UNITED STATES PATENT AND TRADEMARK OFFICE

Thomas Grafenauer

Office Action Summary

DETAILED ACTION

Fig. 5

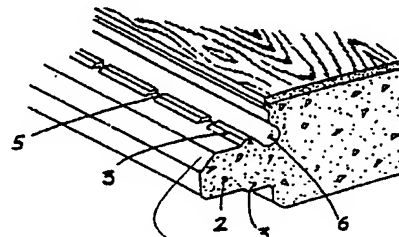
Regarding claim 11, Palsson discloses the structure as discussed above, but does not disclose a recess formed in the tongue of the first longitudinal edge adjacent to the bevel. However, Olofsson et al. discloses a floor board (Figure 5) wherein a tongue (2) comprises a recess (6) adjacent a bevel (a). Therefore, it would have been obvious to one having ordinary skill in the arts at the time of the Applicant's invention to modify the floor board of Palsson to include a recess formed in the tongue of the first longitudinal edge adjacent to the bevel as taught by Olofsson et al. to provide a cavity where excess glue can collect (Col 3, Ln 21-28).

Fig. 6

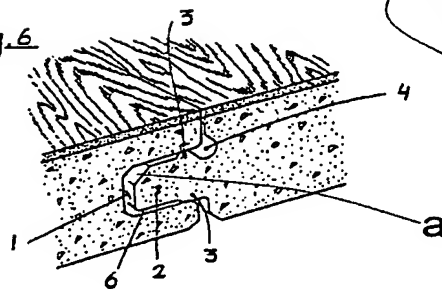
Applicant's arguments filed 3/07/07 regarding claim 1 have been fully considered but they are not persuasive. Applicant argues that the tongue of Palsson "does not comprise a recess and a bevel...instead, the upper mating surface 25 comprises the cavity 6" (Page 15 of Remarks). It is clearly shown in the annotated Figure 6, that the tongue comprises a bevel (23) and a recess (6) adjacent the bevel (23).
